Our Ref: 2018178 Rev A

130 Duckshill Road – Proposed Extension

CLIENT	LAJJA & ALKESH HARIA
PROJECT	130 DUCKSHILL ROAD
TITLE	EXISTING & PROPOSED SITE PLAN
DRAWN	AA
CHECKED	
APPROVED	
DATE	SCALE 1:200@A3
CAD FILE NAME	
DRAW. NO.	130DHR - 00 - 00
REV	A

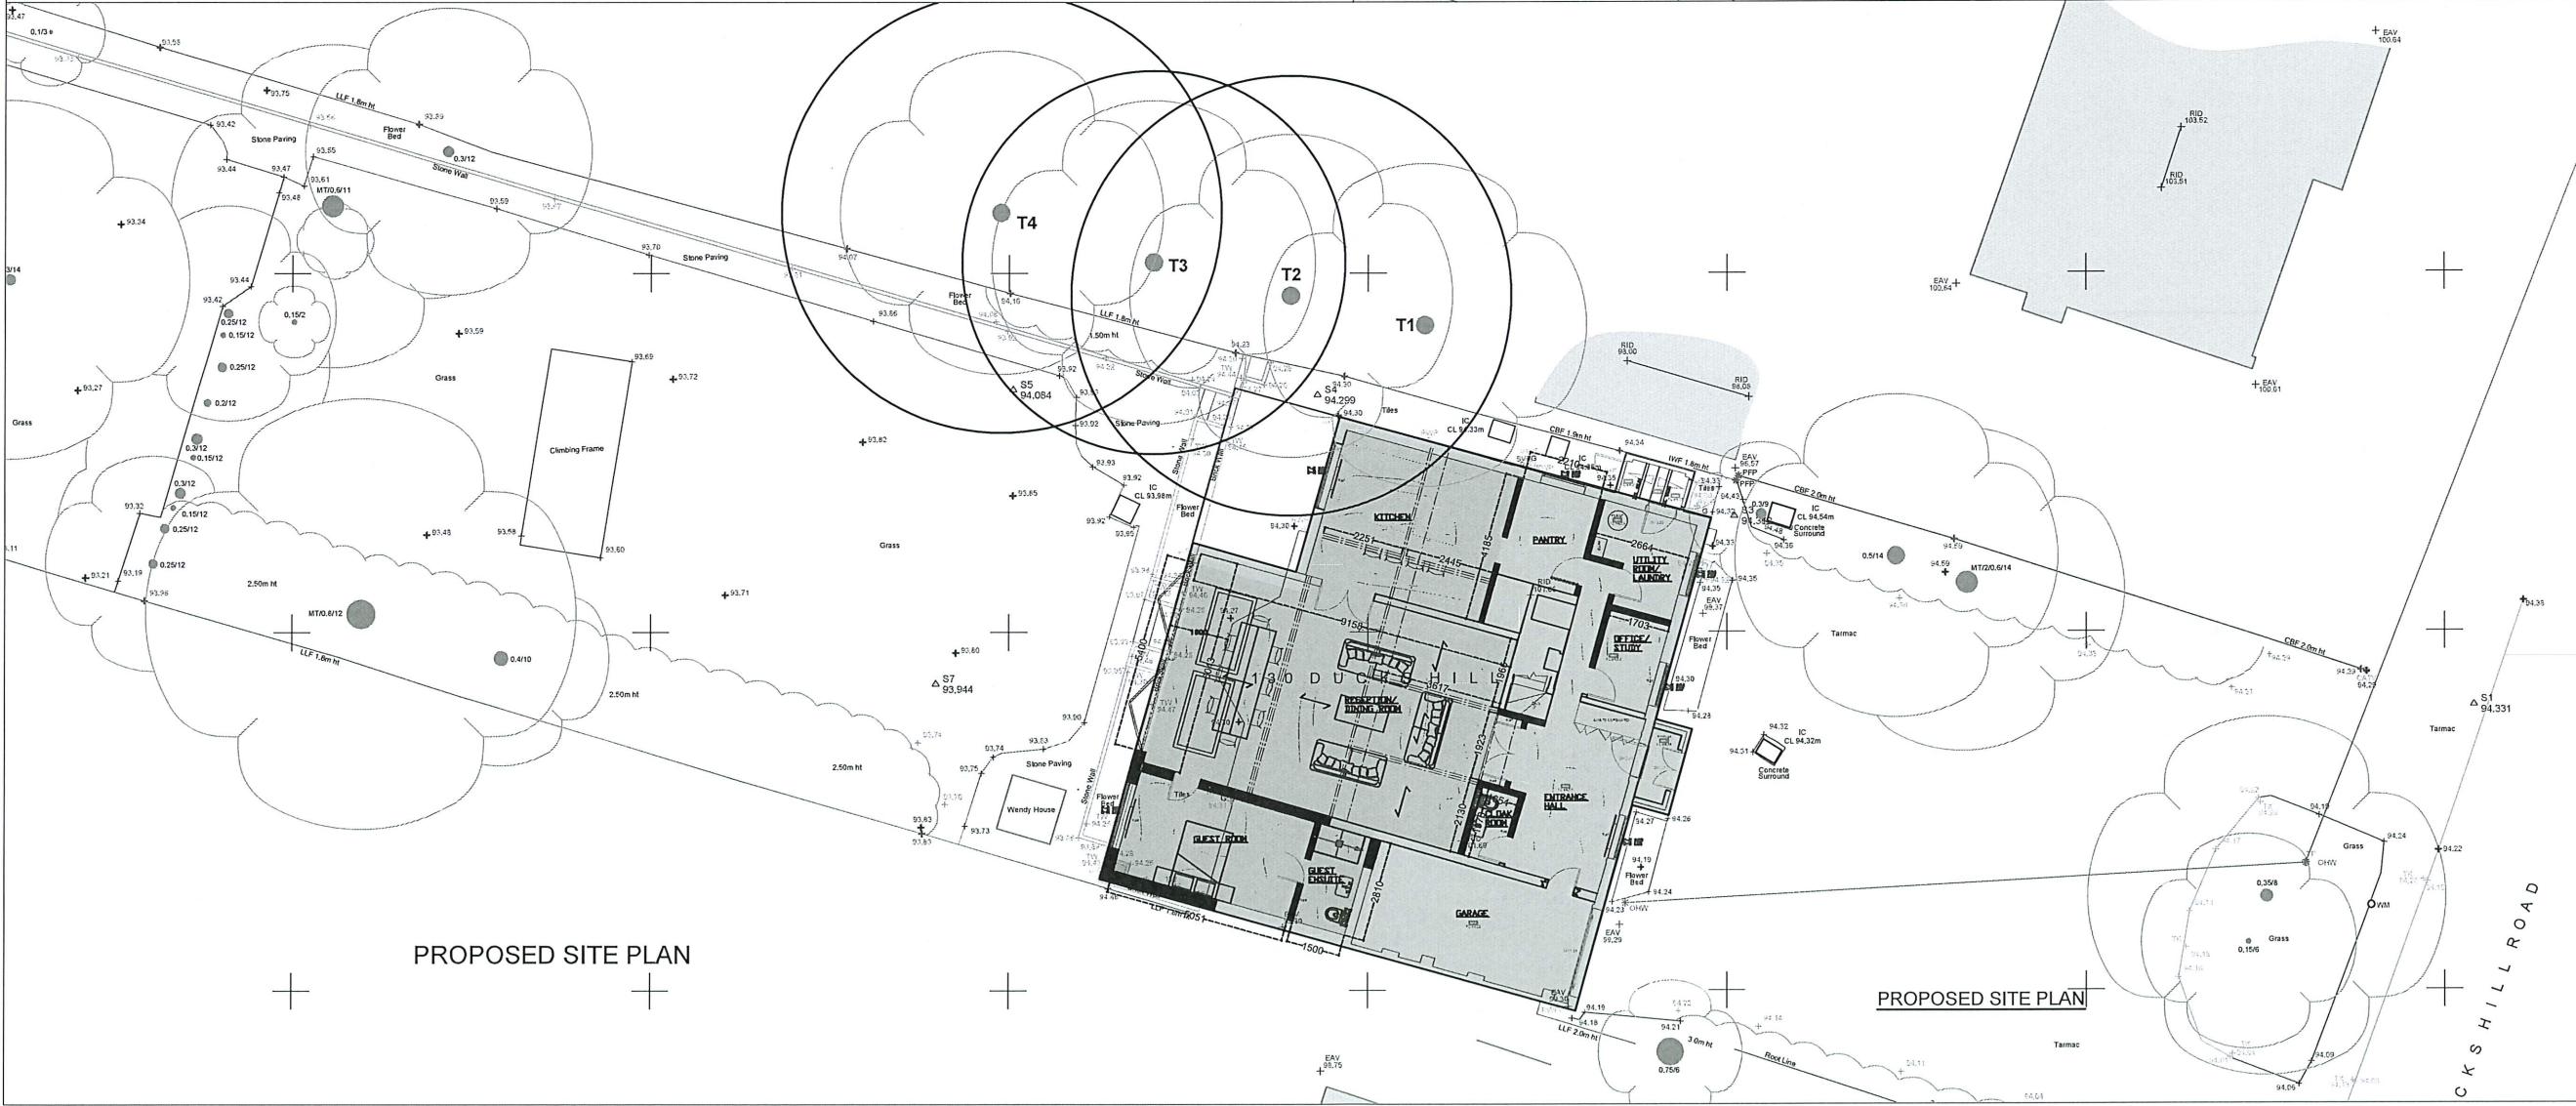
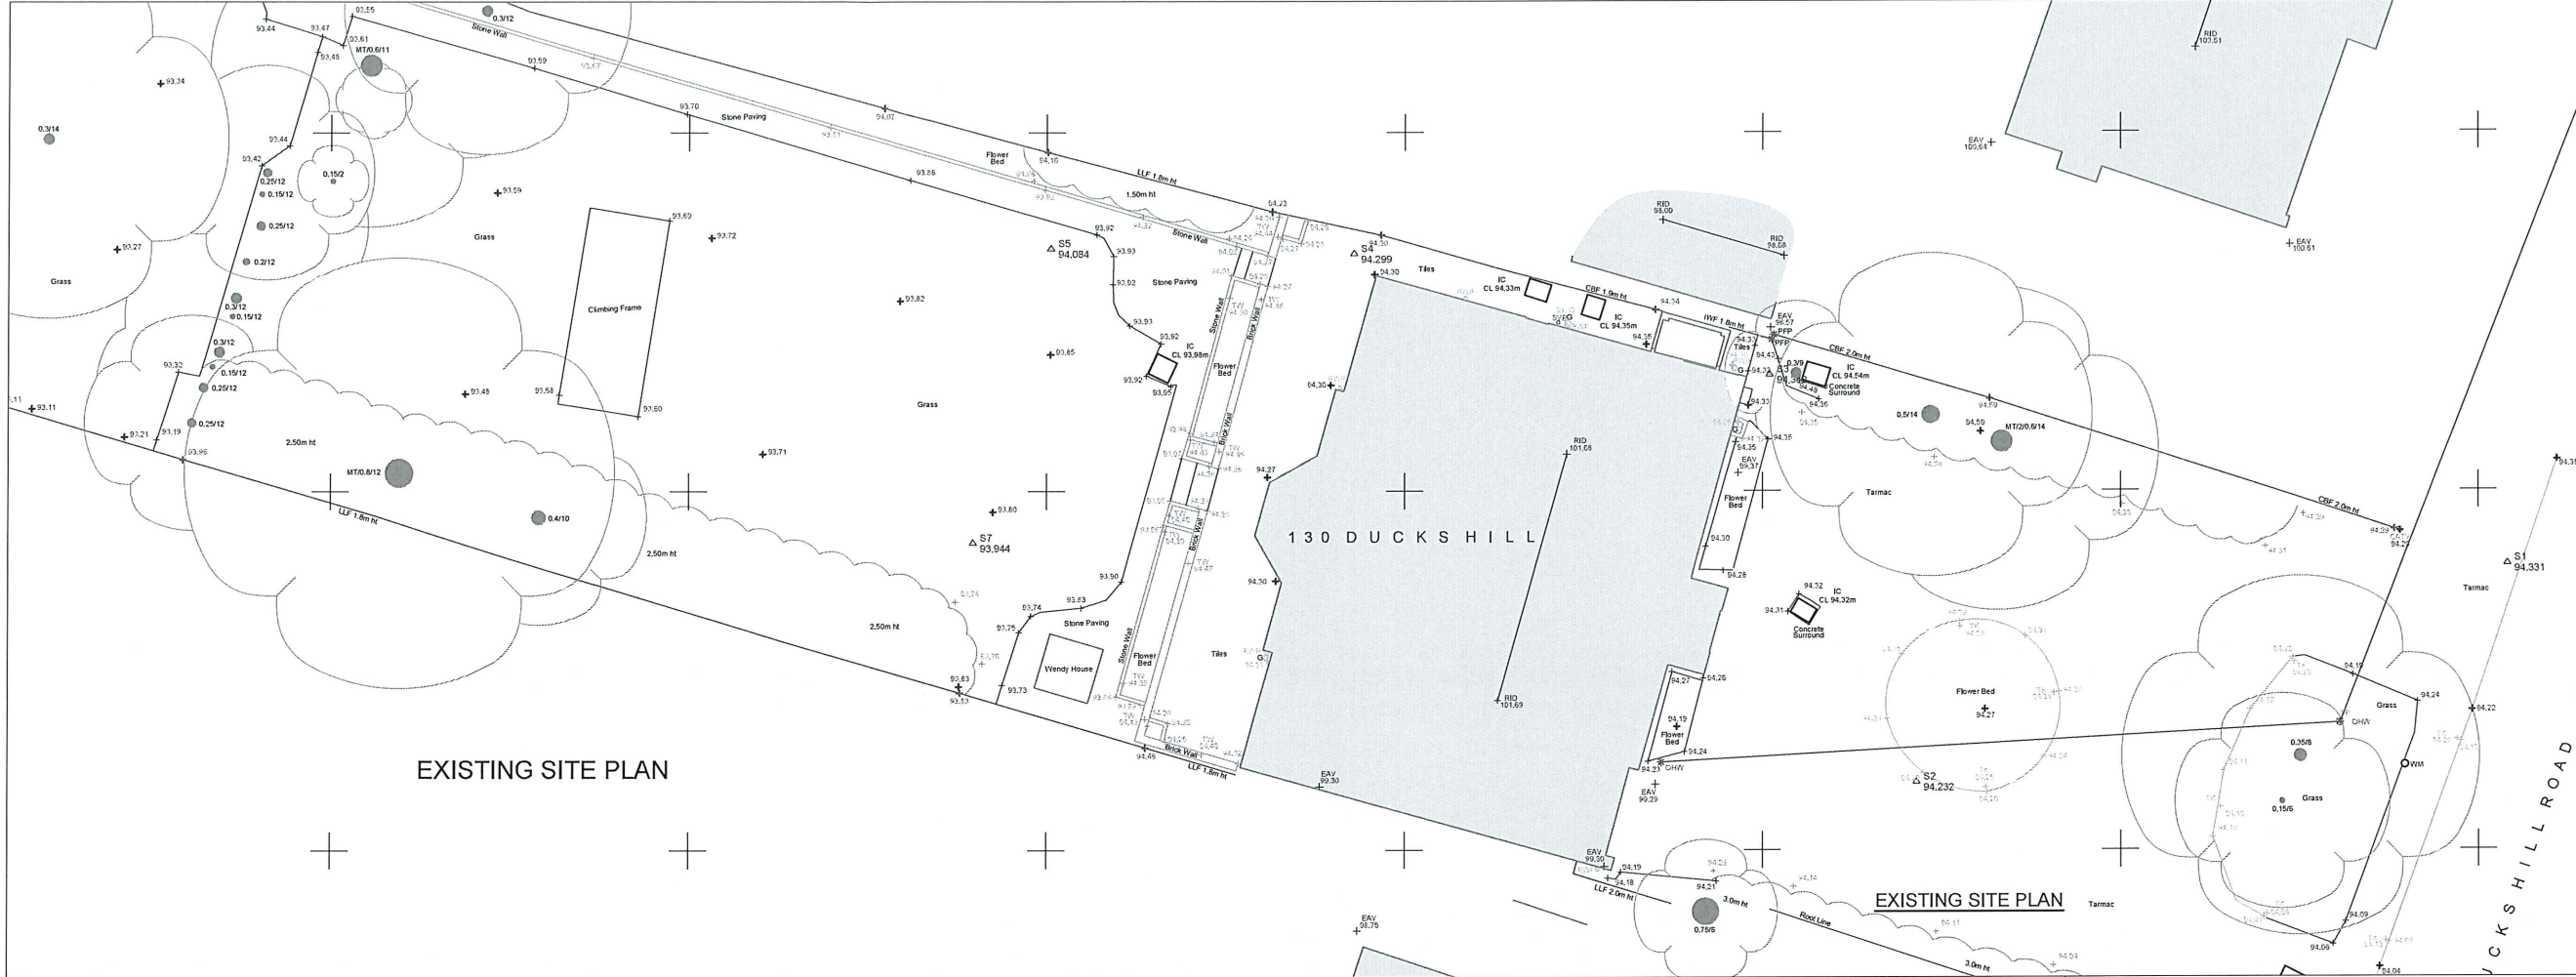
Many thanks for the revised layout plans 130 DHR – 00 – 00 A & 130 DHR – GA – 01 A, these have been revised to reduce the proposed extension size, removing it from the tree root protection zone (TPRZ) of the TPO tree in the adjacent garden.

Trees can have a significant effect on new development if placed within the zone of influence of trees. In this case the existing trees have been protected as extension works have been shown outside the TRPZ. The extension will also be protected by designing foundations in line with the NHBC “building near trees” guidelines, these set out principles of design and required foundation depths/details to protect development from the effects of trees.

- Foundations to be designed in accordance with NHBC guidance given proximity of trees.
- No construction works in the TPRZ

ASSESS FOUNDATIONS
FOR MOTIVAZ LORRAL
CYCLOS. - MOTIVAZ HT = 2m
DRAINAGE = 7m

$\frac{7}{20} = 0.35$

NHSC 4.2 TEL = 1

FIND DEPTD = 2.0m.
